**SECOND RESPONSE TO REQUEST FOR ADDITIONAL INFORMATION  
PERMIT TO OPERATE COMPOSTING FACILITY  
PERMIT TO CONSTRUCT LEACHATE TREATMENT FACILITY  
PERMIT TO OPERATE RESOURCE RECOVERY FACILITY  
WASTE TIRE GENERAL PERMIT  
AND  
PERMIT TO MAINTAIN CLOSED CLASS I SANITARY LANDFILL  
PREPARED FOR**

Mr. Kim B. Ford, P.E.  
Solid Waste Section  
Division of Waste Management  
Florida Department of Environmental Regulation  
4520 Oak Fair Boulevard  
Tampa, Florida 33610-7347

**RE: SUMTER COUNTY SOLID WASTE FACILITIES**

**PERMIT NO.:**      **S060-211179 - SOLID WASTE COMPOSTING**  
**WT60-211205 - WASTE TIRE STORAGE**  
**S060-211182 - M.R.F.**  
**SF60-211255 - LONG-TERM CARE**  
**SC60-211181 - LEACHATE TREATMENT**

**REVISED GROUNDWATER  
ELEVATIONS MAP**

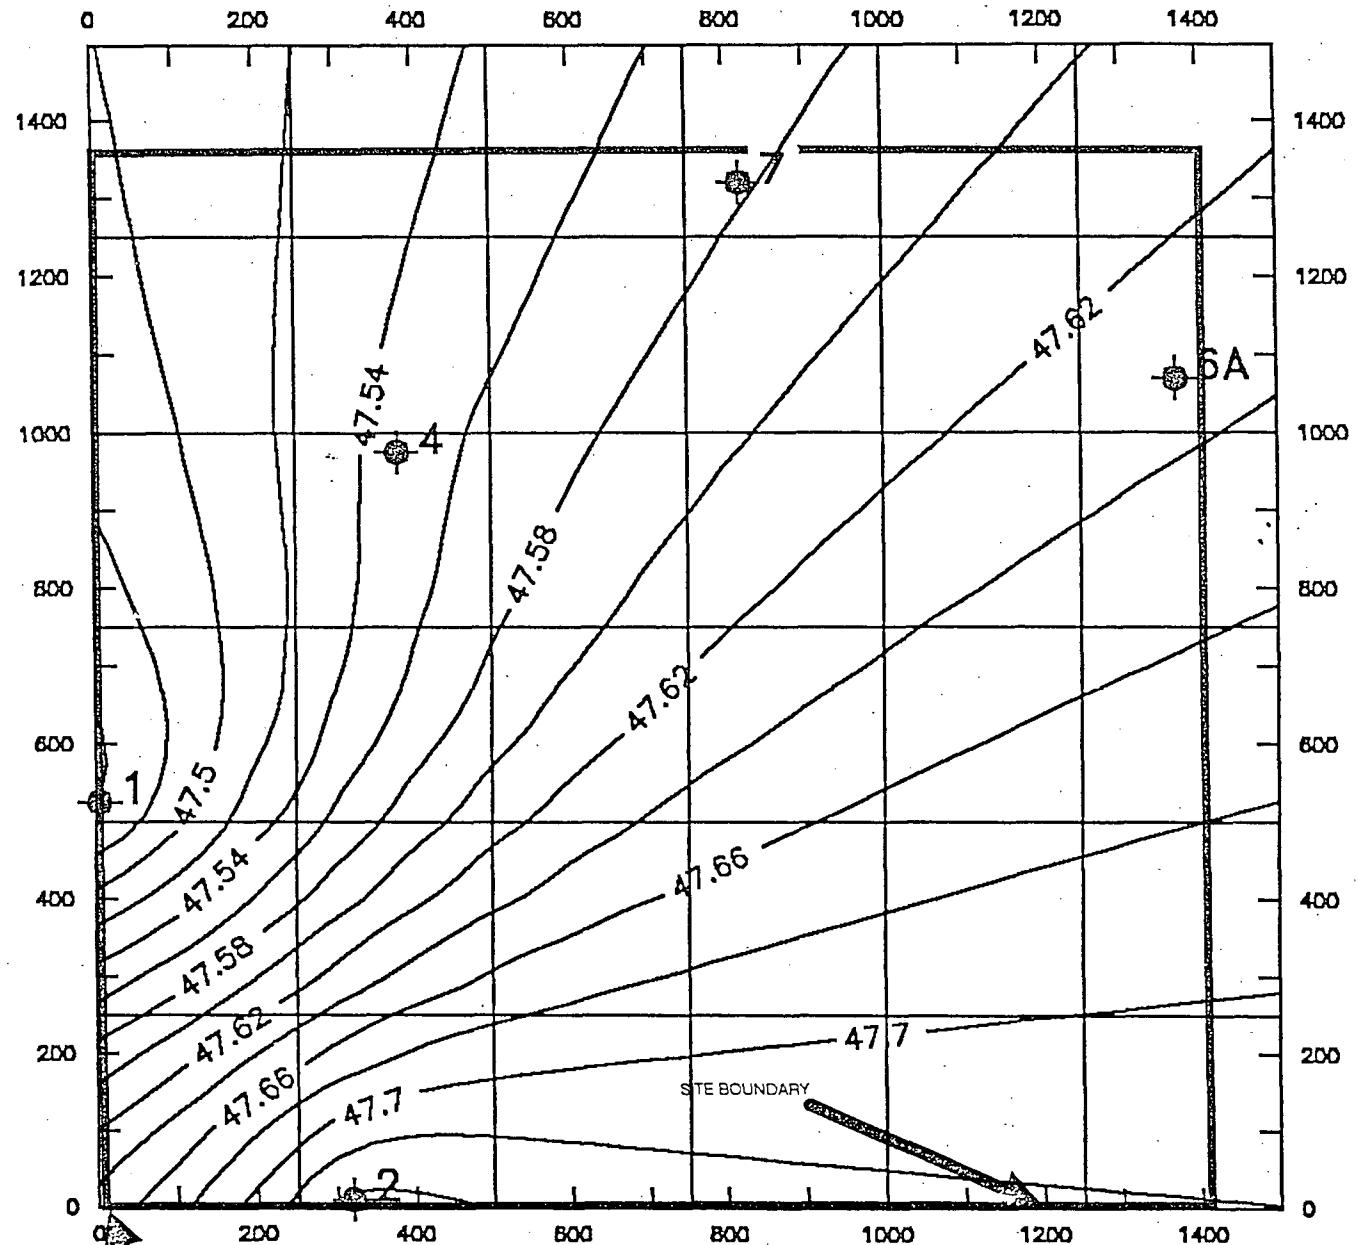
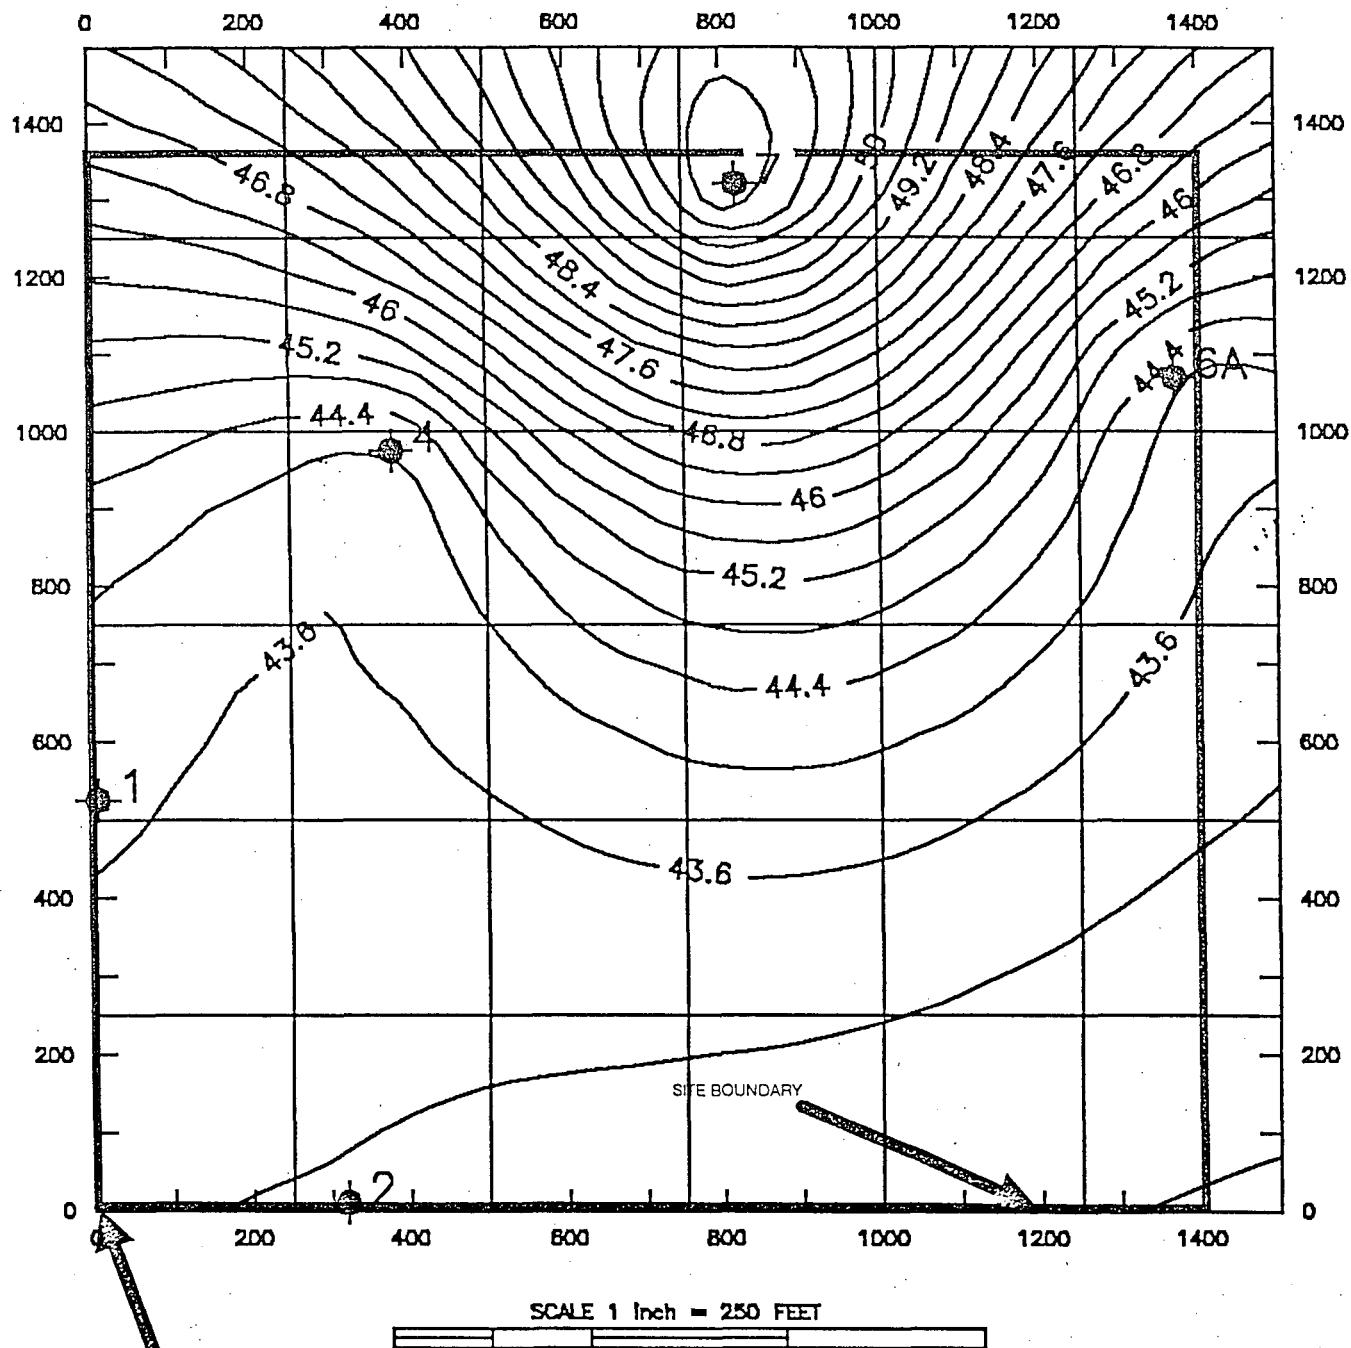
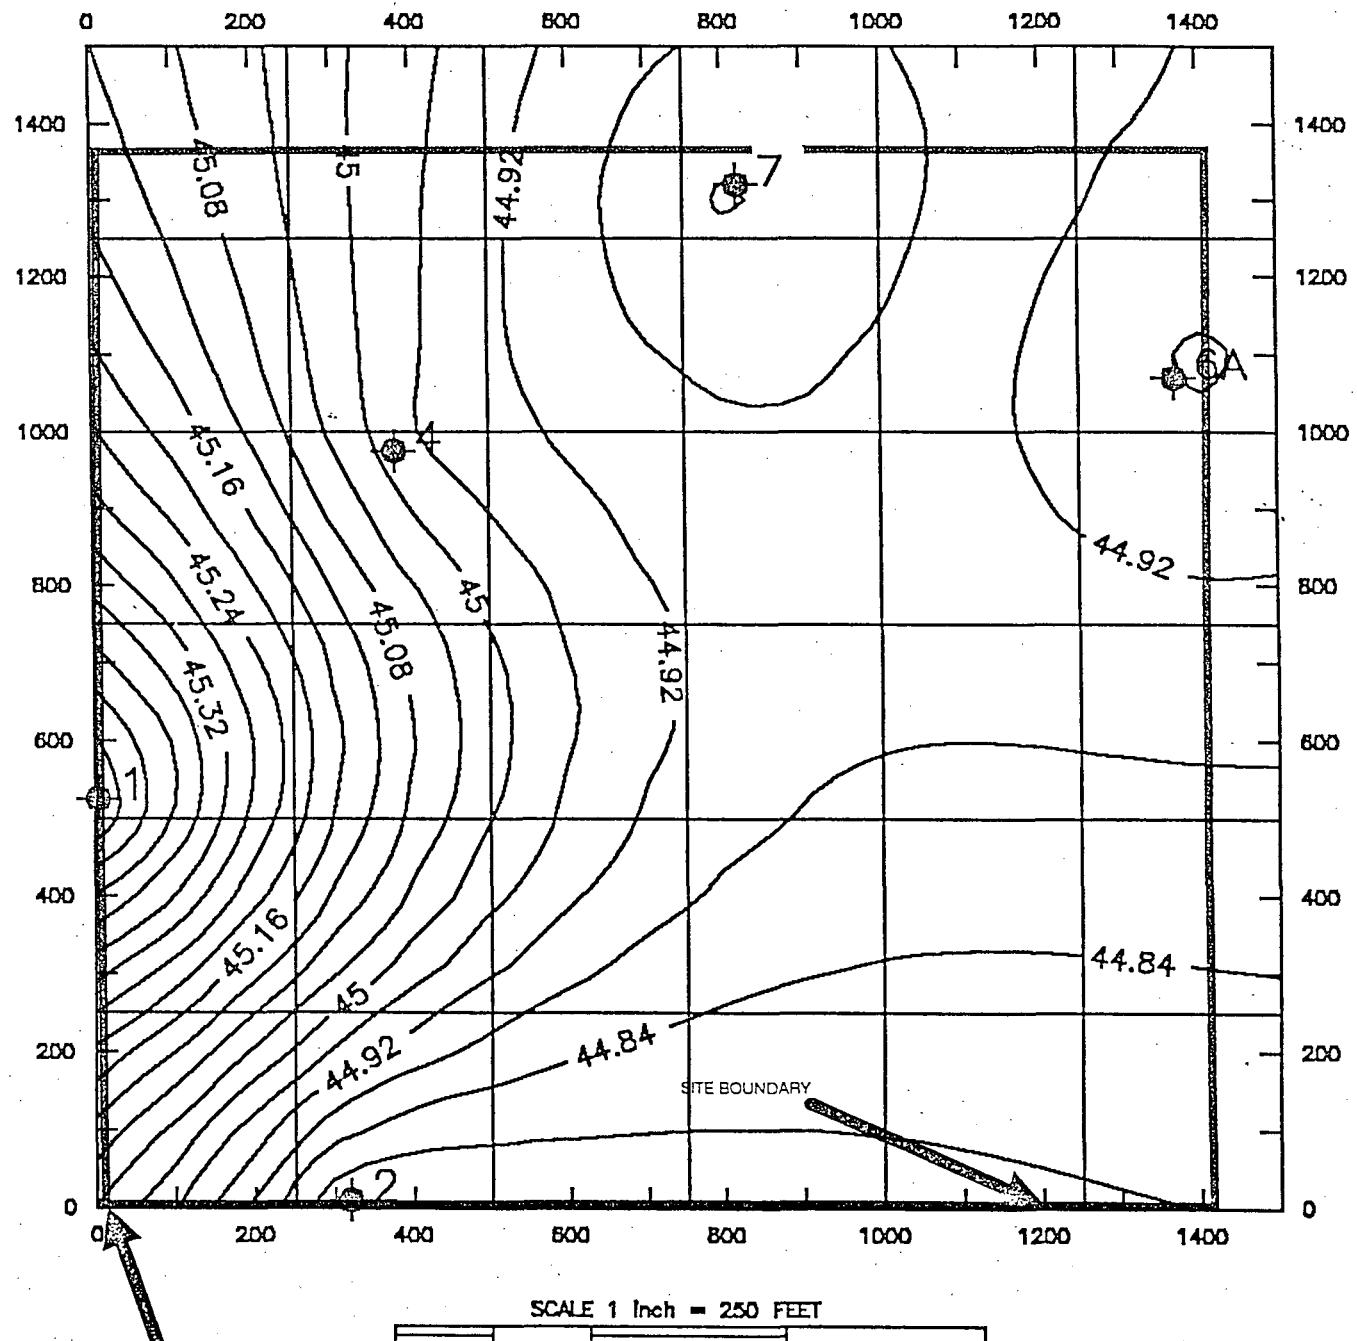
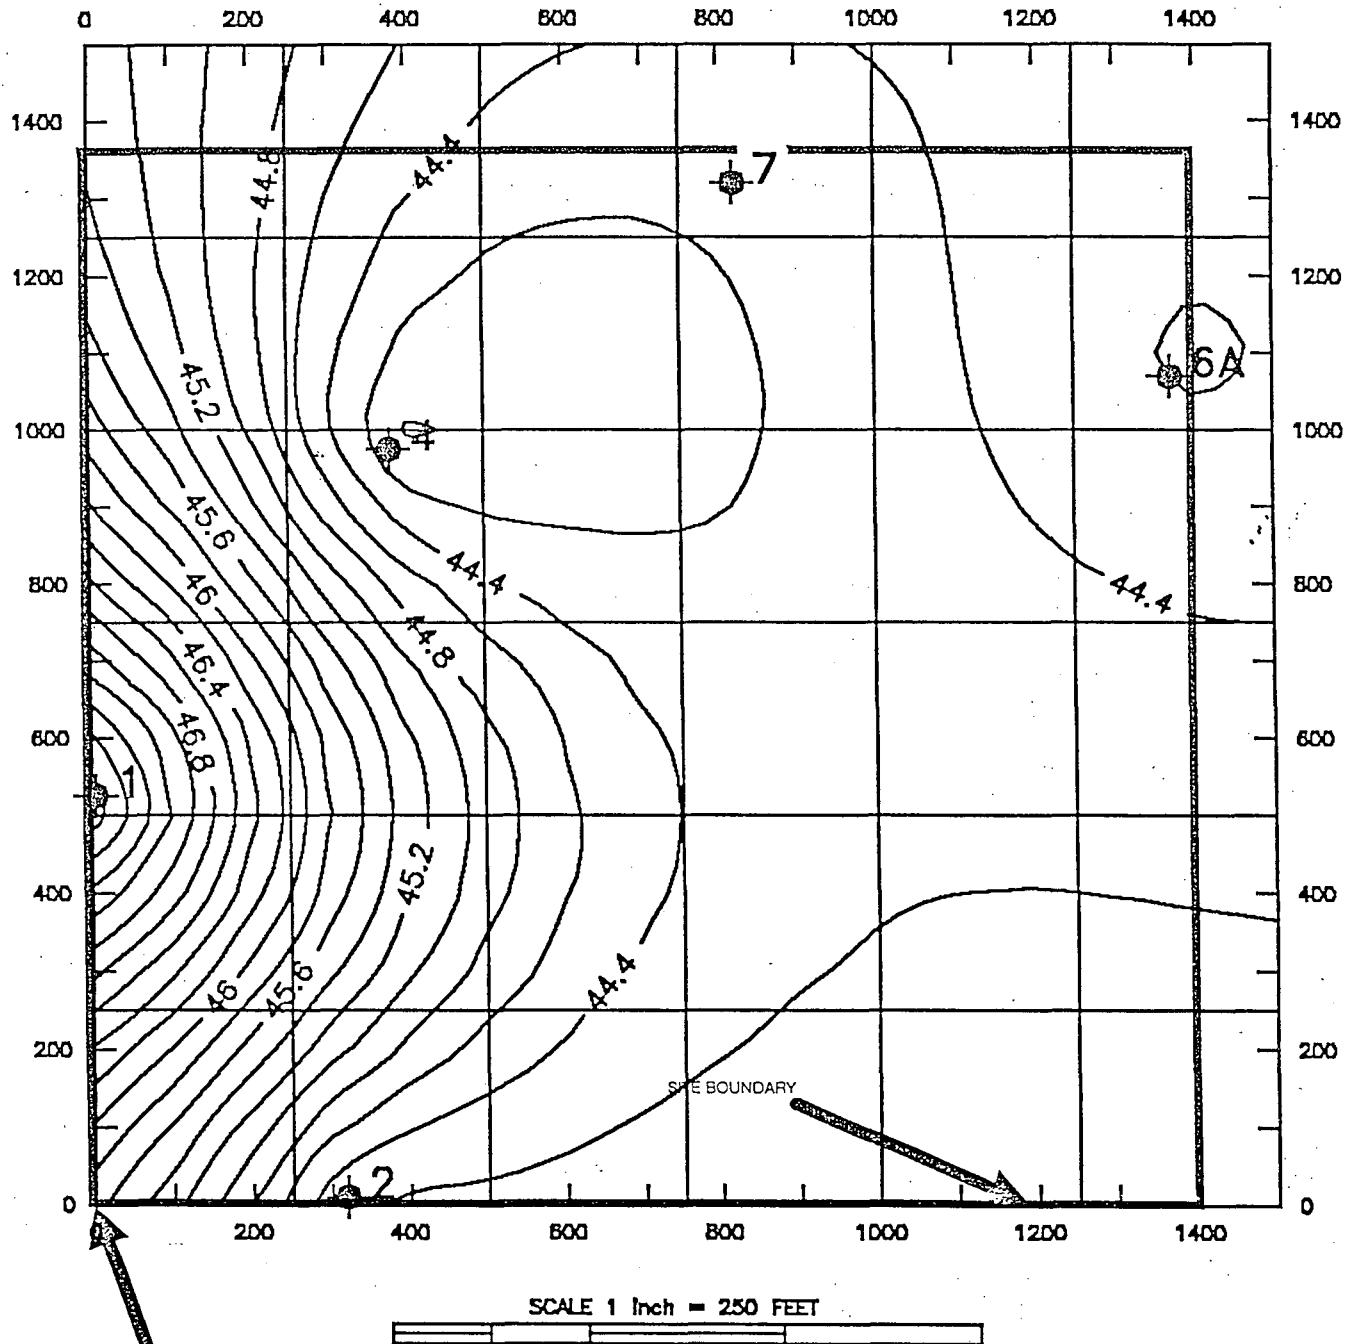
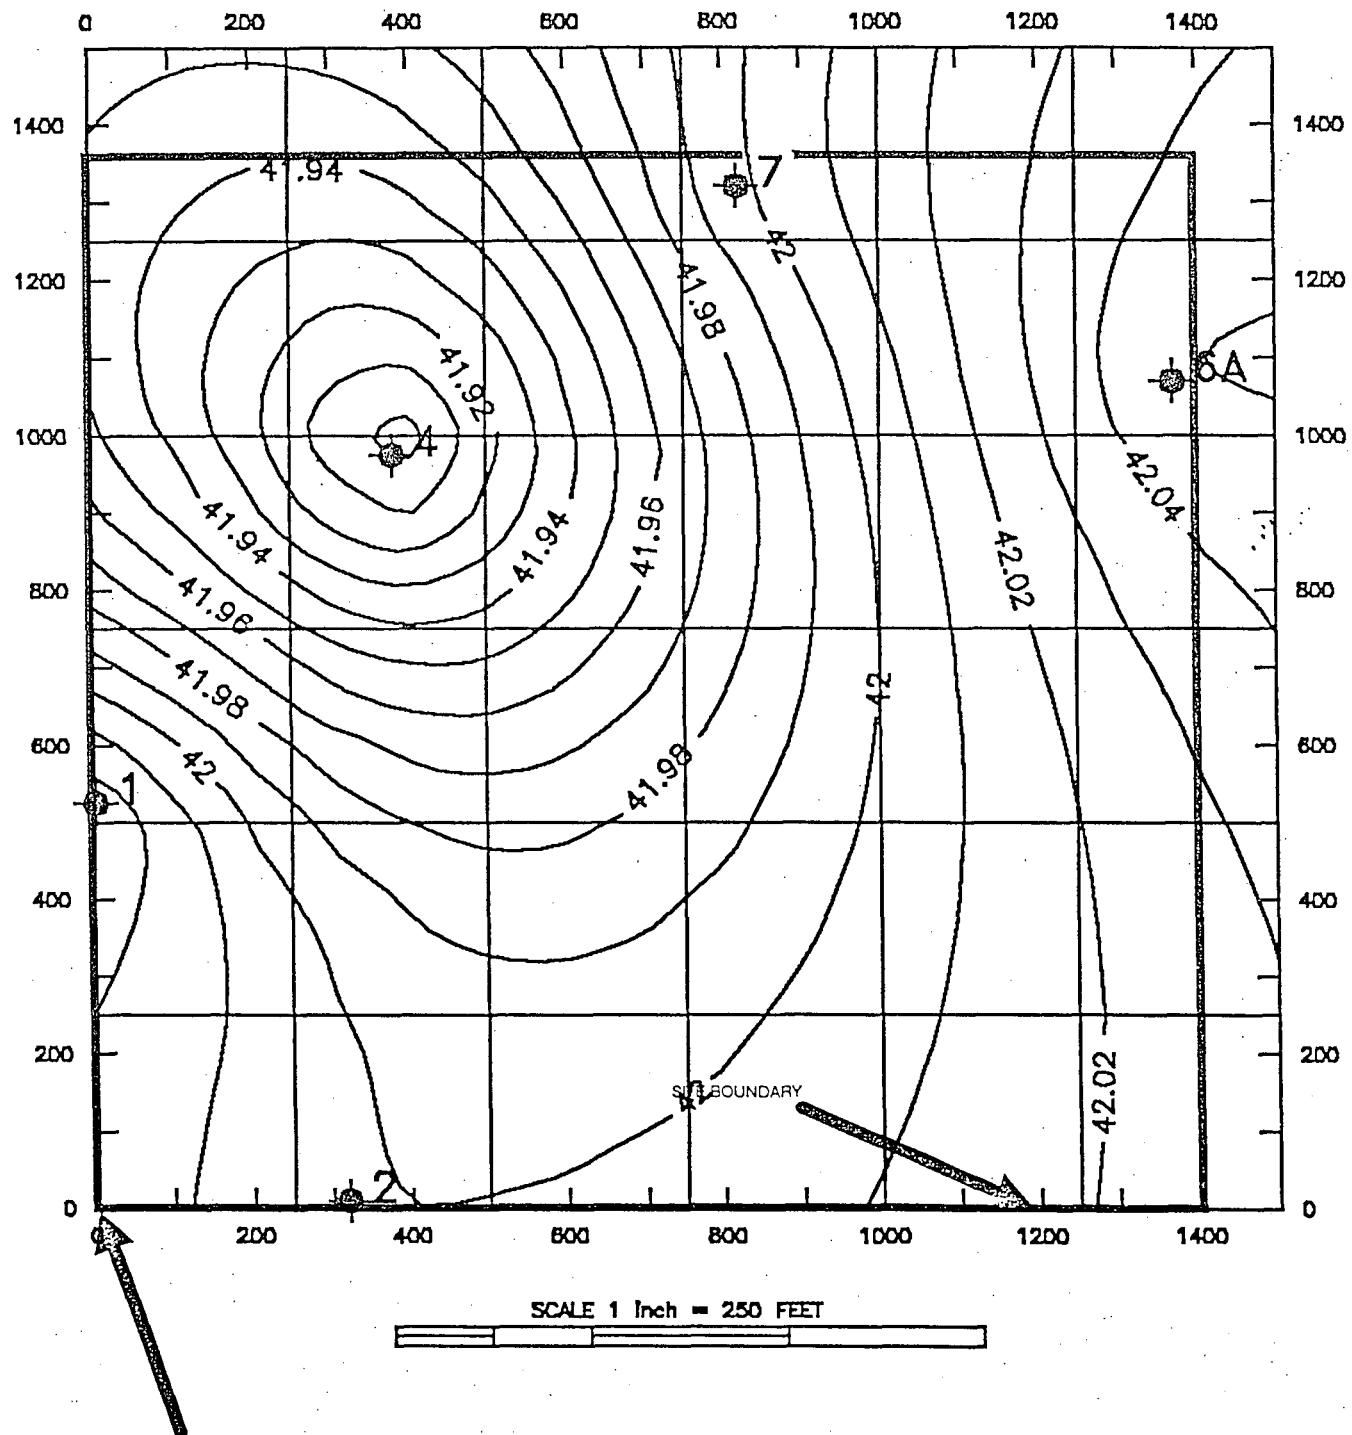
4. The elevations given are N.G.V.D. The monitoring interval is quarterly.
5. The Groundwater elevation contour maps in Appendix F need some explanation. The asterisks seem to denote monitor well locations, but do not coincide with monitor well locations on the map provided in Appendix D. The data by each asterisk does not appear to correspond with the data provided in tabular form. The contours do not reflect the numerical values printed by each asterisk.

5. The bottom left-hand corner of the Groundwater Elevation Maps presented in our response dated May 29, 1992 corresponds to the southwest corner of the present facility. The asterisks did denote the location of the monitoring wells and did generally coincide with the locations shown on the map enclosed in Appendix D of the response dated May 29, 1992. The numbers should have been the well numbers. This has been corrected and revised Groundwater Elevation Maps are enclosed in Appendix C.
